STATE OF MAINE  
DEPARTMENT OF TRANSPORTATION  
16 STATE HOUSE STATION  
AUGUSTA, MAINE  
04333-0016

April 23, 2010  
Subject: **Westbrook**  
Federal Project No's: NH-1523(400) &  
STP-1311(800)X  
State Pin No's: 015234.00 & 013118.00  
**Amendment No. 2**

Make the following **CHANGES** to the plans in pen and ink for **PIN 15234.00, Westbrook William Clark Drive:**

DATE: 09-16-08  
 SCALE: AS SHOWN  
 SHEET 44 OF 105

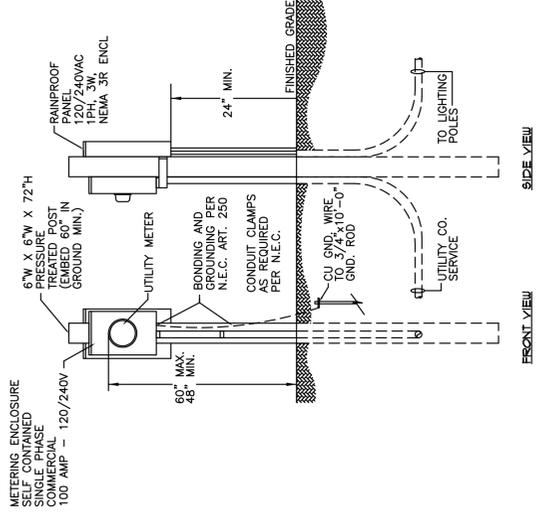
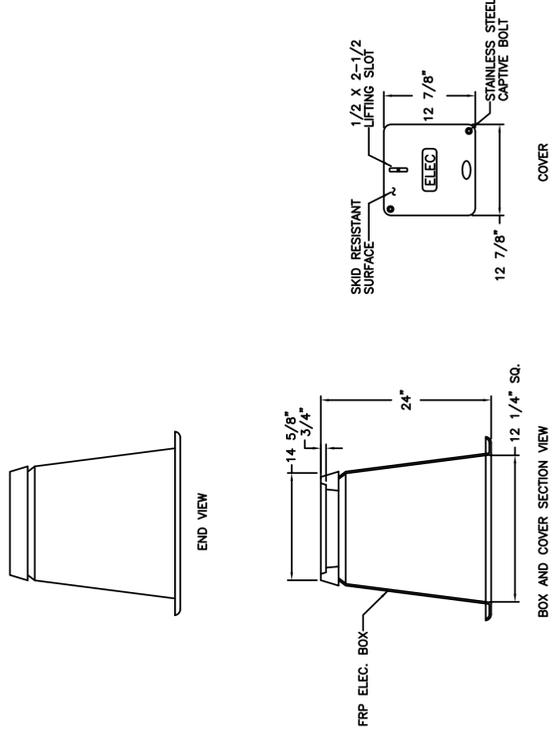
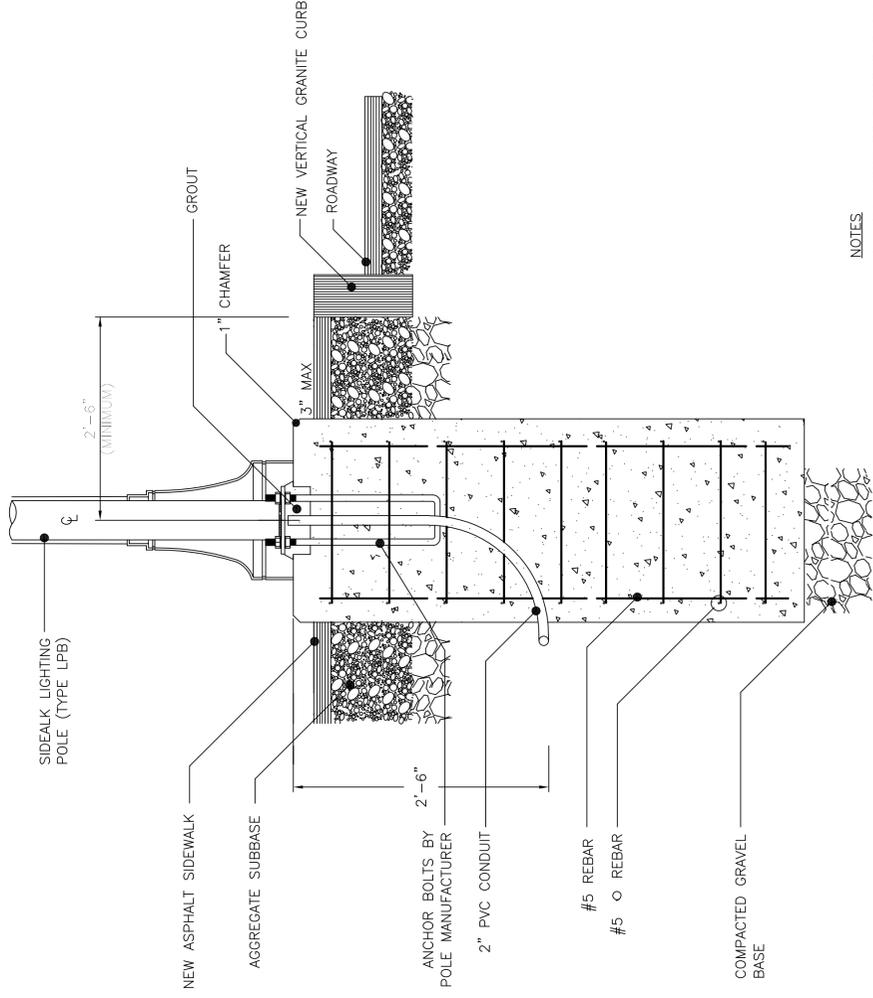
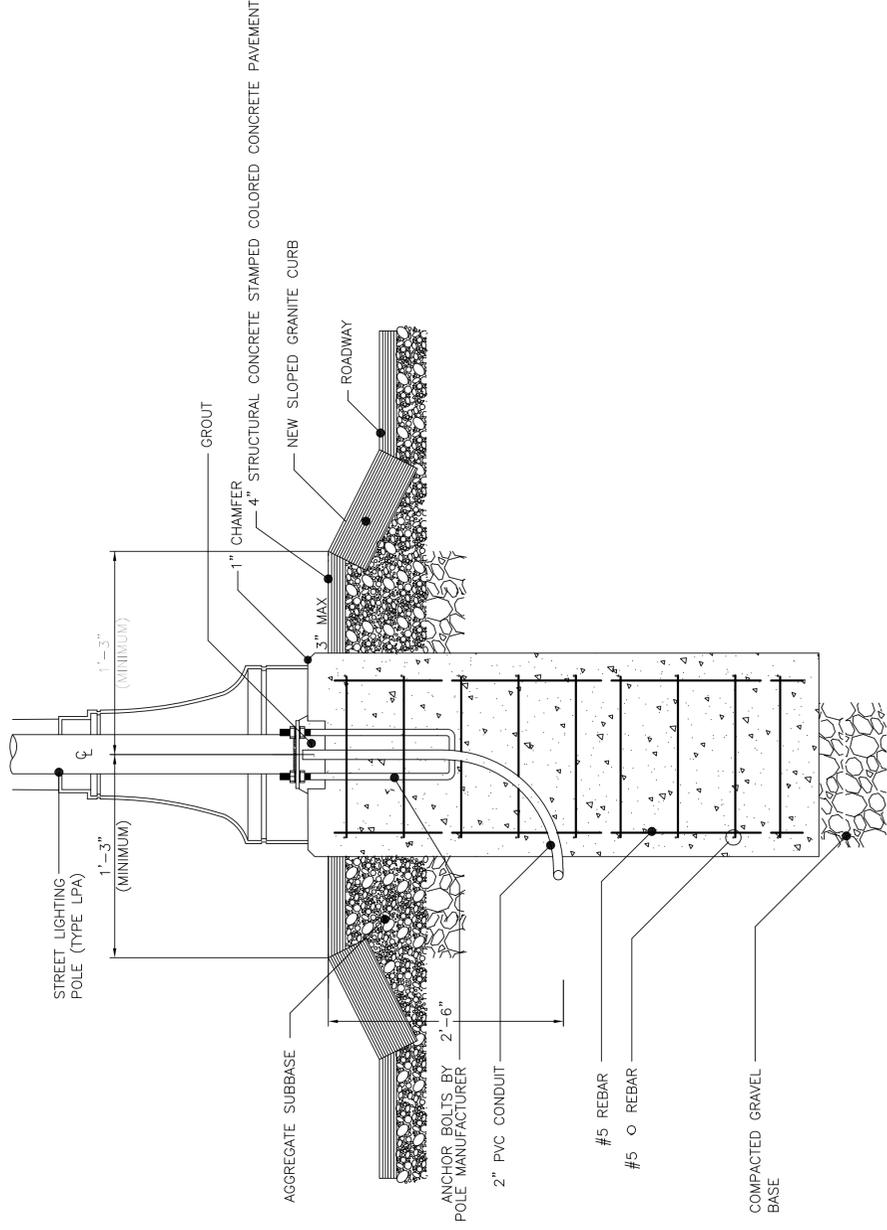
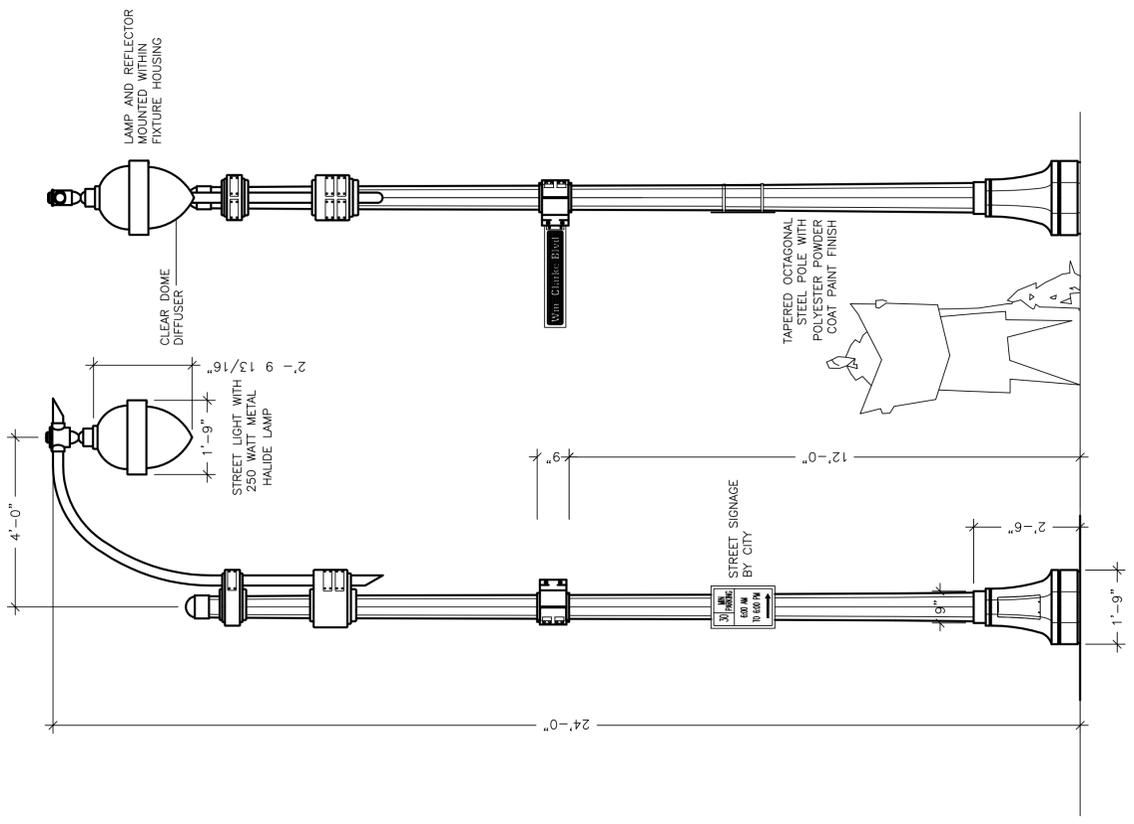
*Highway Lighting Luminaire:* Two (2) area lights per lighting Standard with Type 3 IES distribution, ballast with modular connectors, photocell control, gasketed clear dome diffuser and 250-watt metal halide lamp. Luminaire finish shall be polyester powder coat paint (RAL6005). The luminaire shall conform to the details shown on Sheet 44 of the plans.

*Lighting Standard:* 11 gage tapered steel pole, 8-sided (*Visco* #VI-WB21-OCT-21), with 2-1/2 inch schedule 40 steel pipe bracket arms (*Hadco* #SA9075), 2-piece cast aluminum pole castings, 24" long banner arms, and a 2-piece cast aluminum base cover. Pole finish shall be polyester powder coat paint over a galvanized sub-finish (RAL6005). The lighting standard and bracket arm shall conform to the details shown on Sheet 44 of the plans.

*Highway Lighting Luminaire:* Identical to Type A except one (1) light per Lighting Standard. The luminaire shall conform to the details shown on Sheet 44 of the plans.

*Lighting Standard:* Identical to Type A except 24-ft. high with single bracket arm. The lighting standard and bracket arm shall conform to the details shown on Sheet 44 of the plans.
